MEMORANDUM

To: El Paso County
From: Sean Hays, PE
Kimley-Horn and Associates, Inc.
Date: September 16, 2021
Subject: Design Documentation - Proposed Roundabout at Meadowbrook Pkwy and Newt Dr

MEADOWBROOK PARKWAY ROUNDABOUT

5

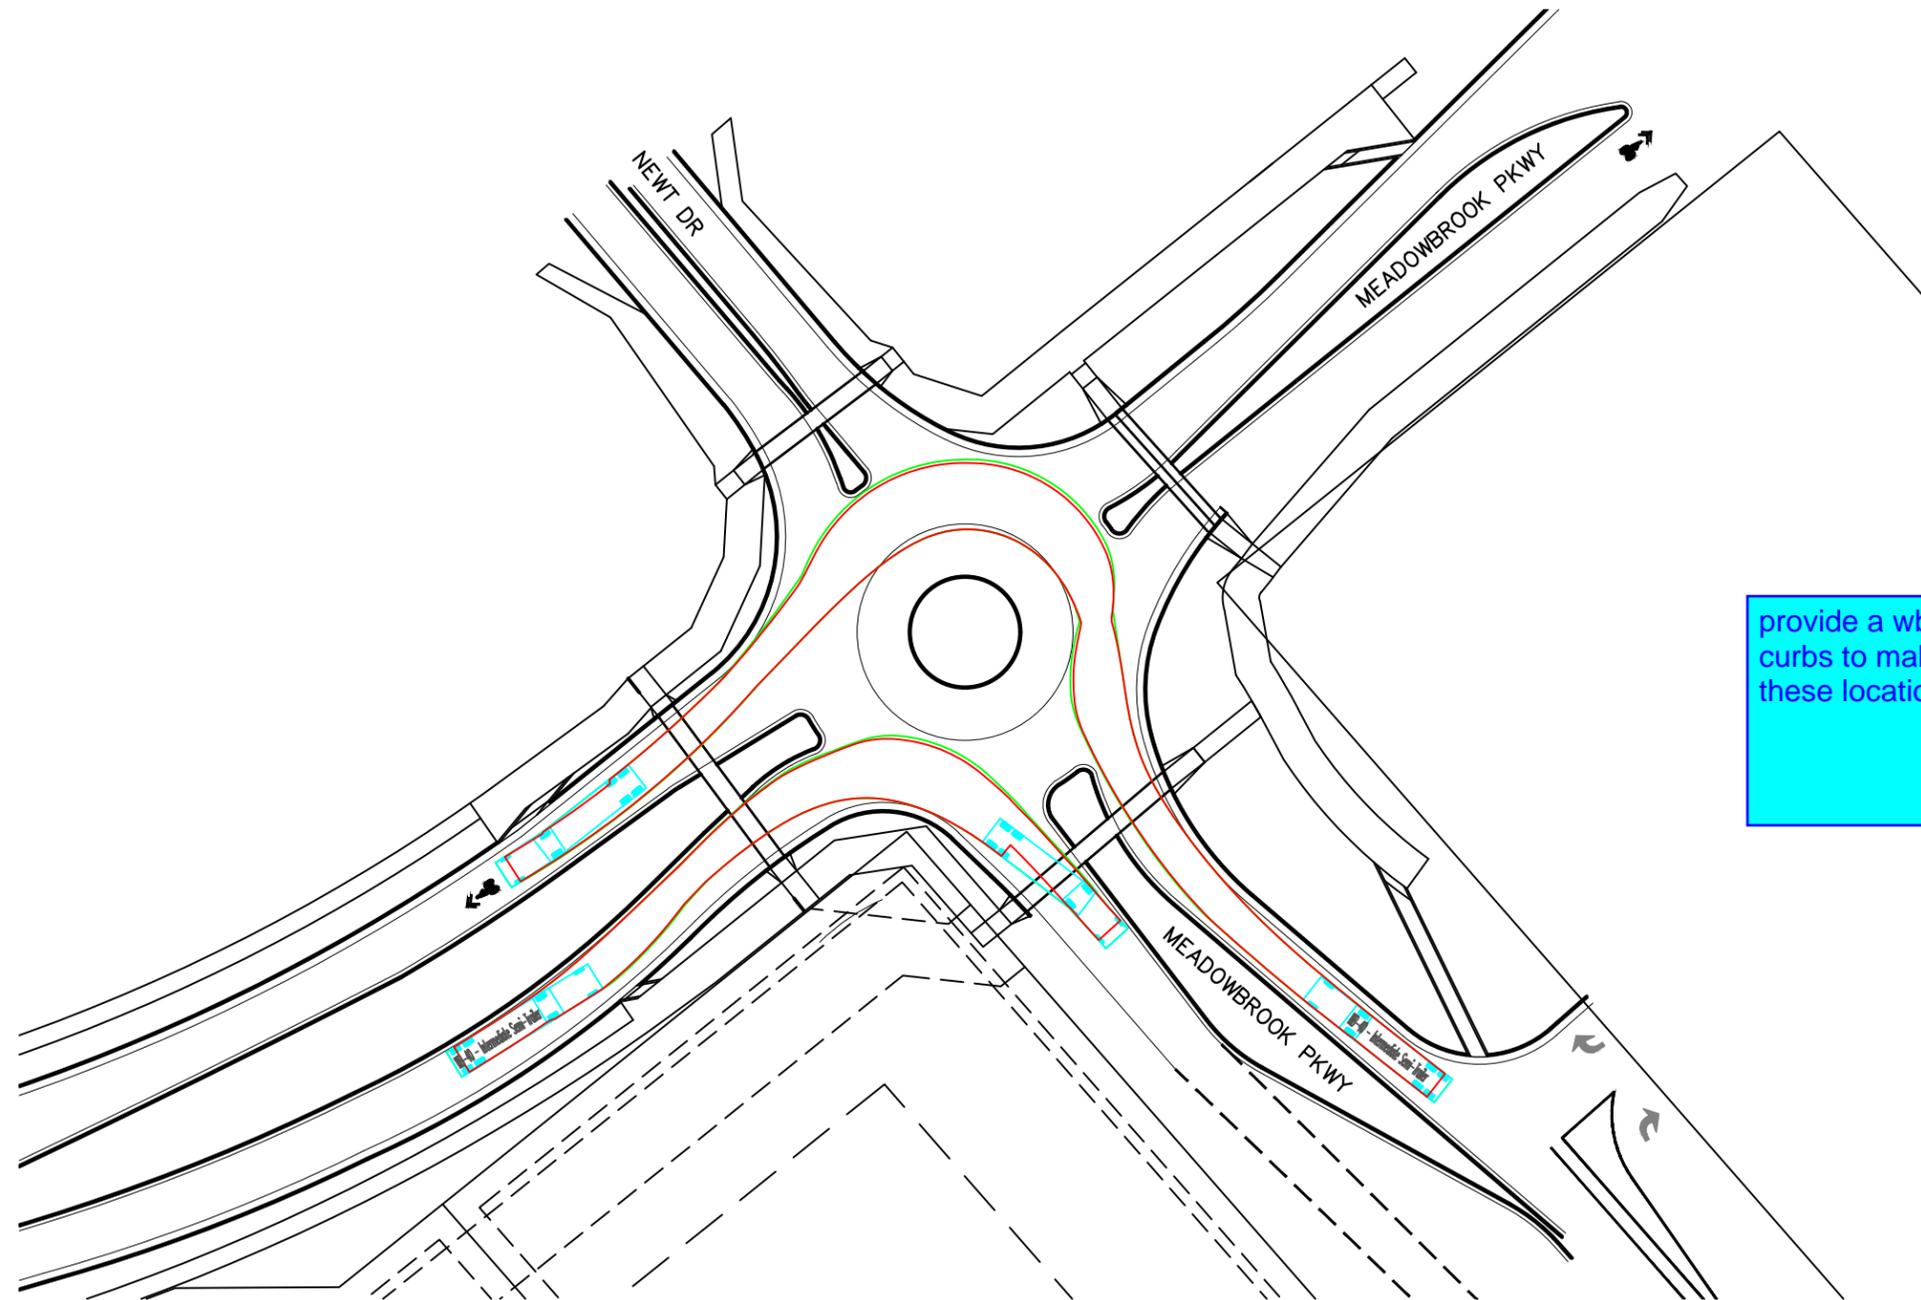
provide a wb-65 to show where they go over curbs to make sure utilities are not installed at these locations

SB FASTEST PATH

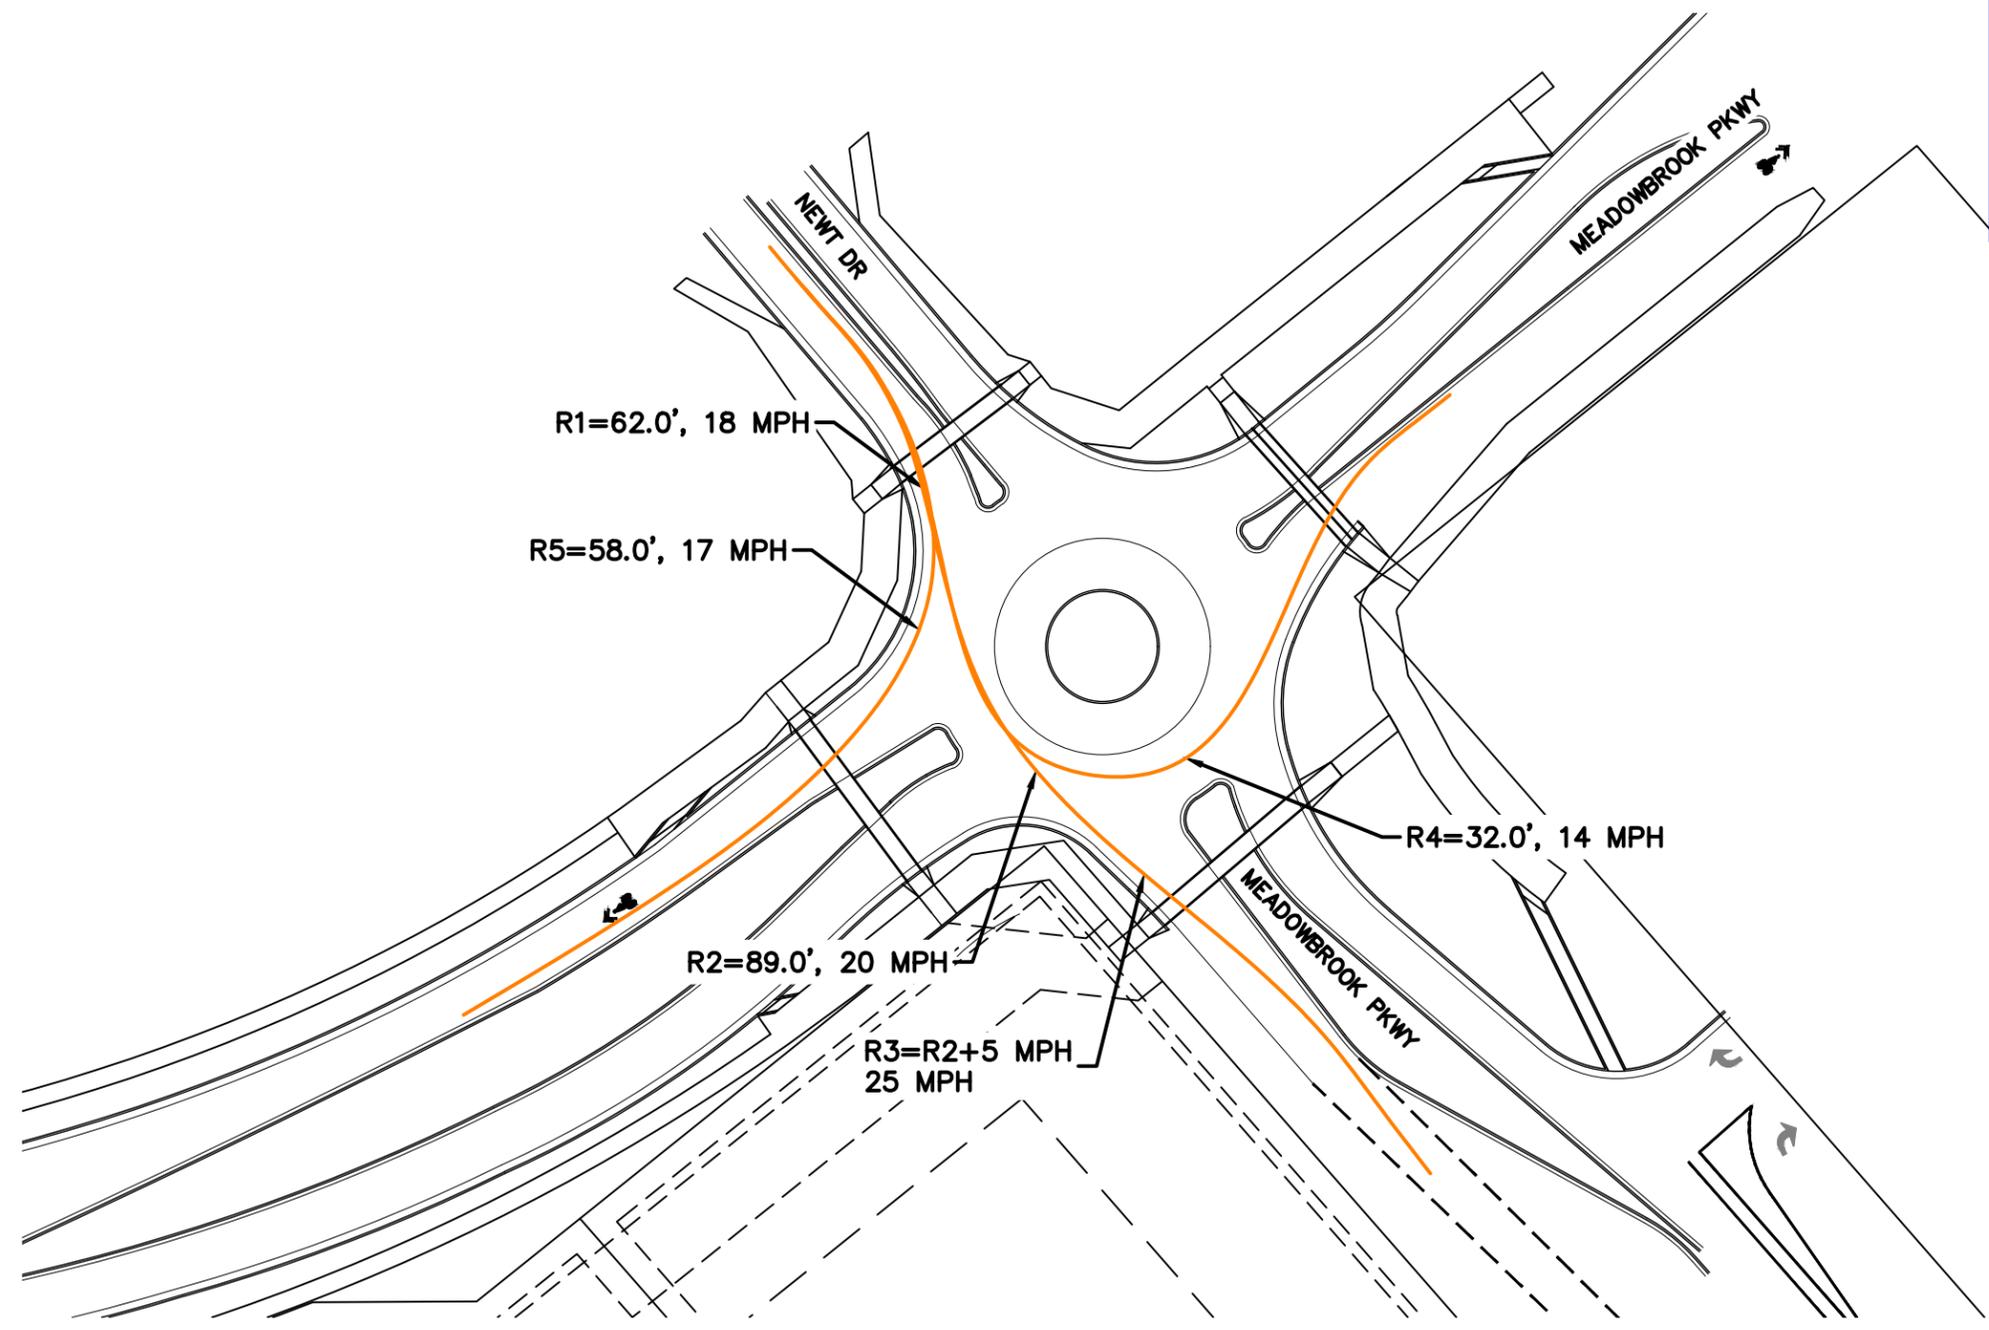
check fastest path offsets and calculations.
The values did not update from the previous exhibit.

MEADOWBROOK ROUNDABOUT BICYCLE PLAN

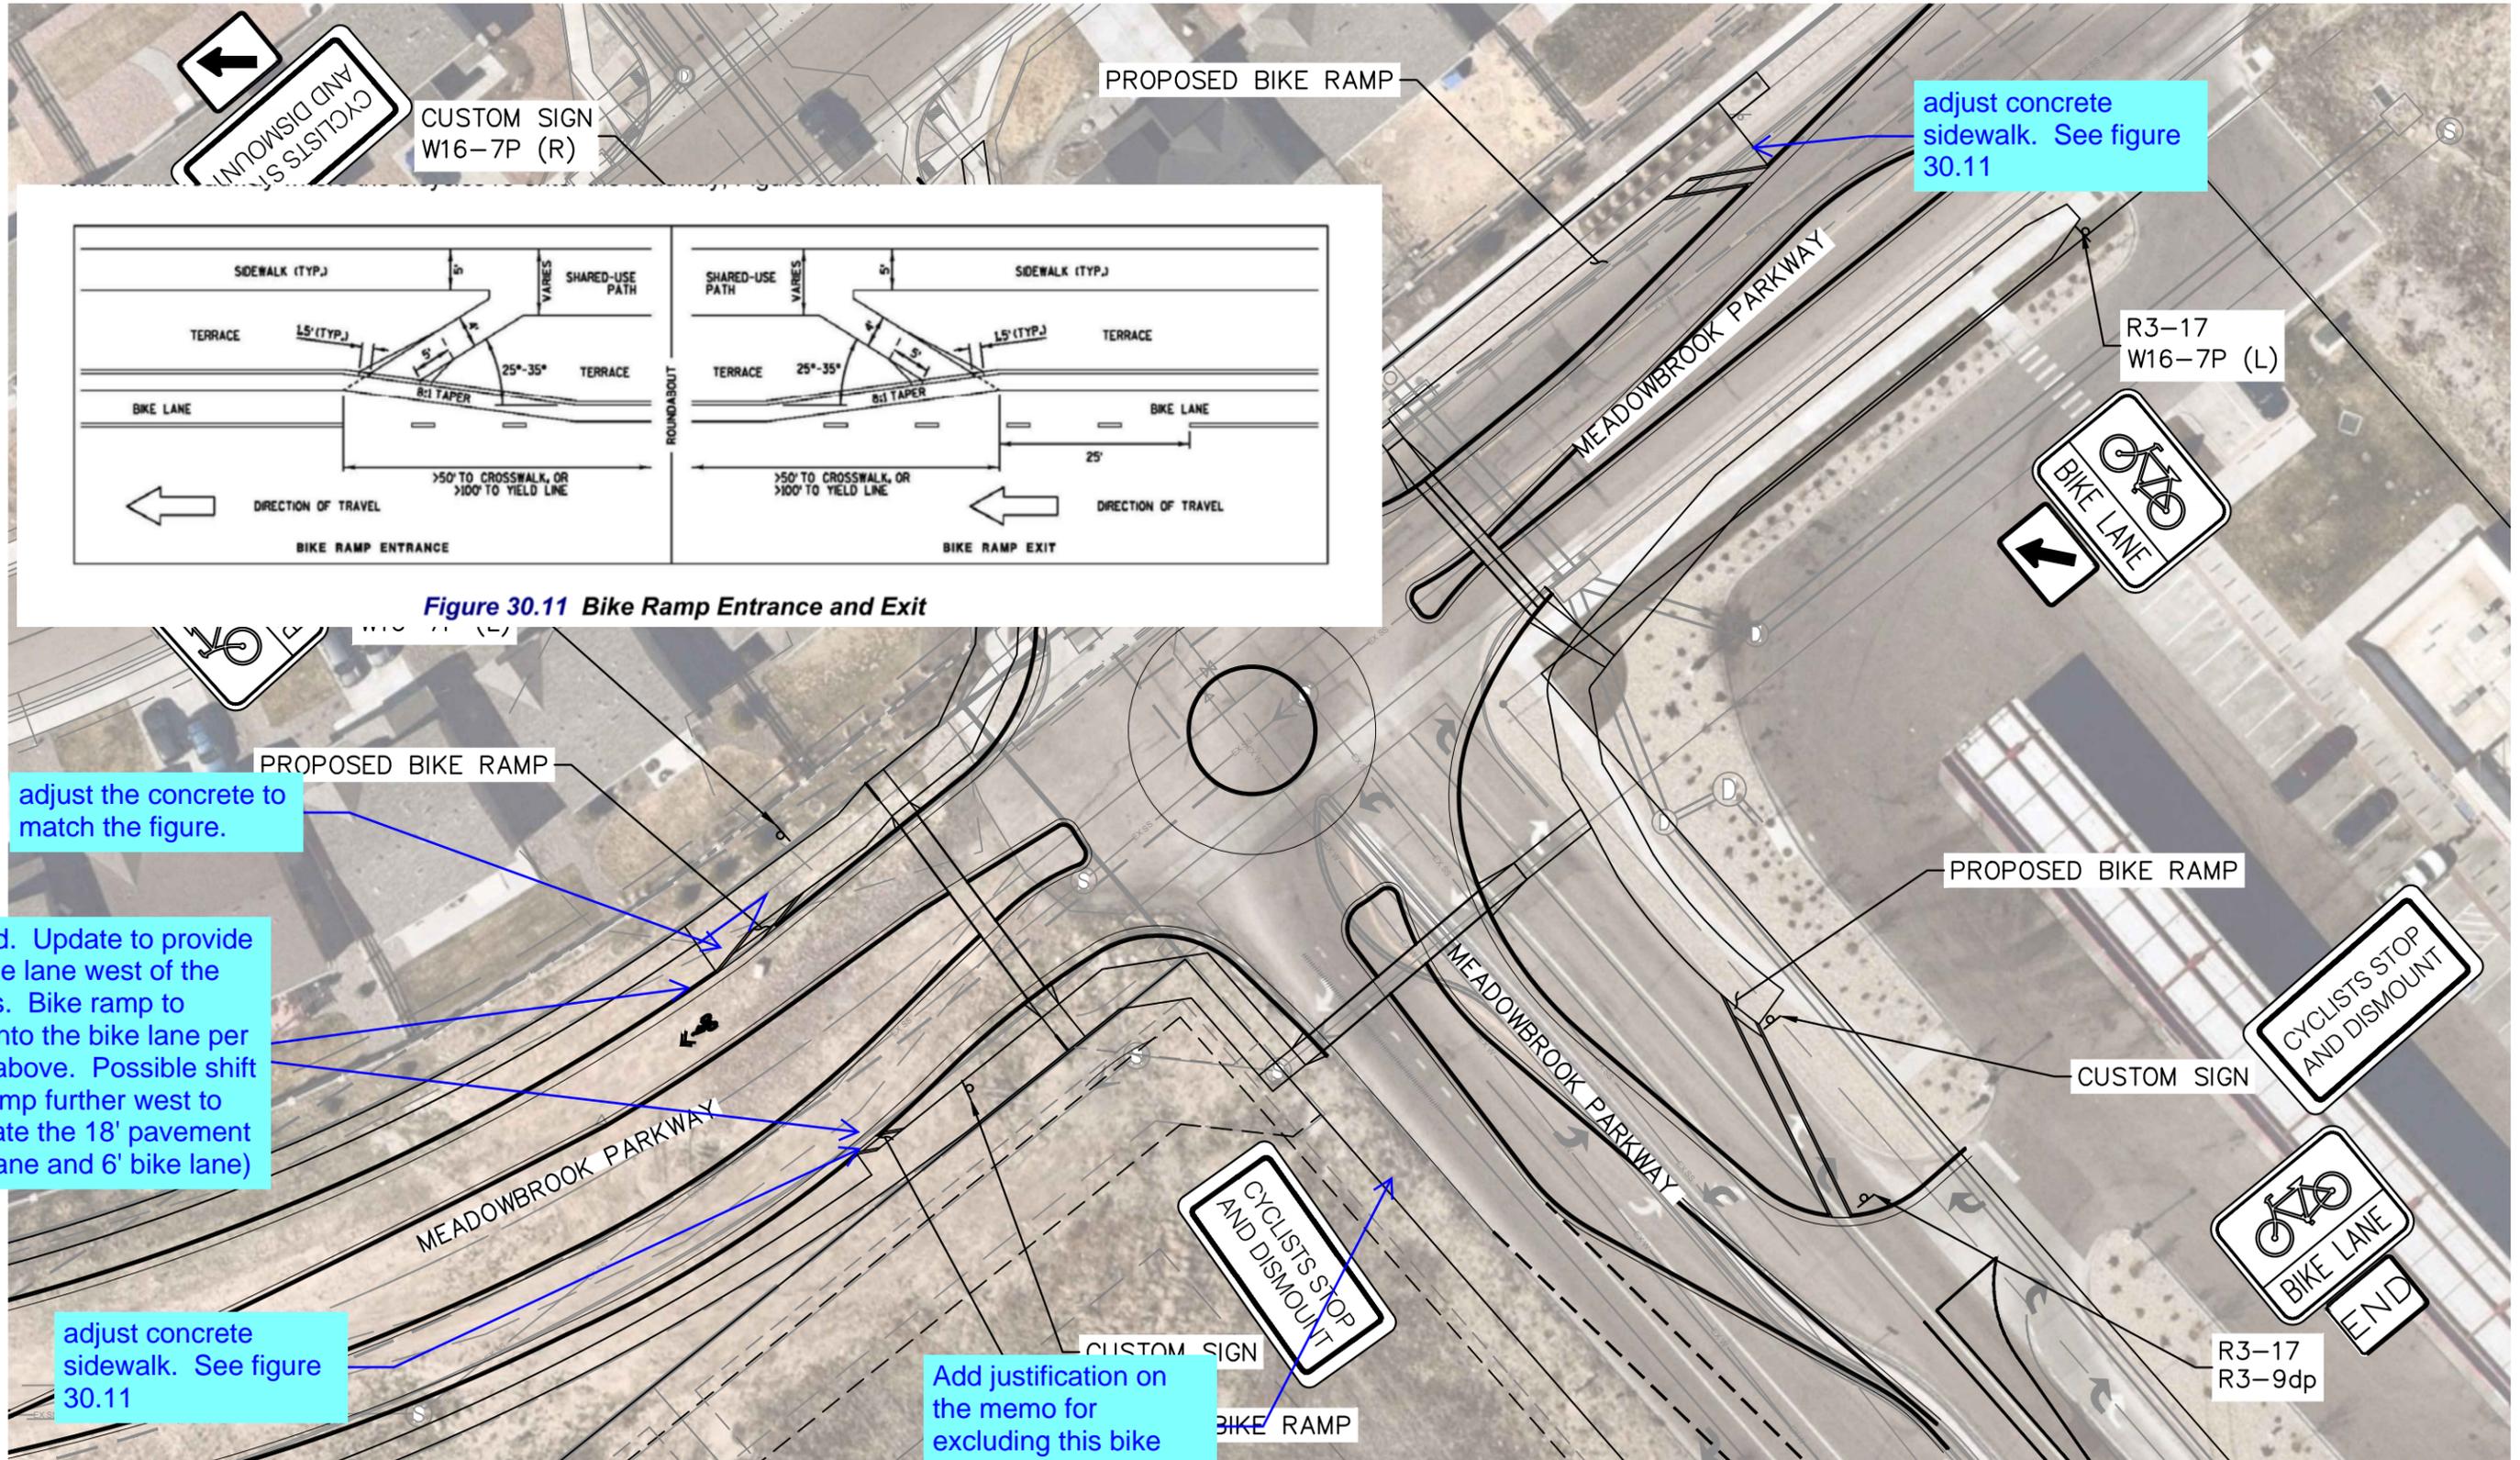
adjust concrete sidewalk. See figure 30.11

adjust the concrete to match the figure.

Unresolved. Update to provide the 18' wide lane west of the bike ramps. Bike ramp to transition into the bike lane per the figure above. Possible shift the bike ramp further west to accommodate the 18' pavement wide (12' lane and 6' bike lane)

adjust concrete sidewalk. See figure 30.11

Add justification on the memo for excluding this bike ramp.
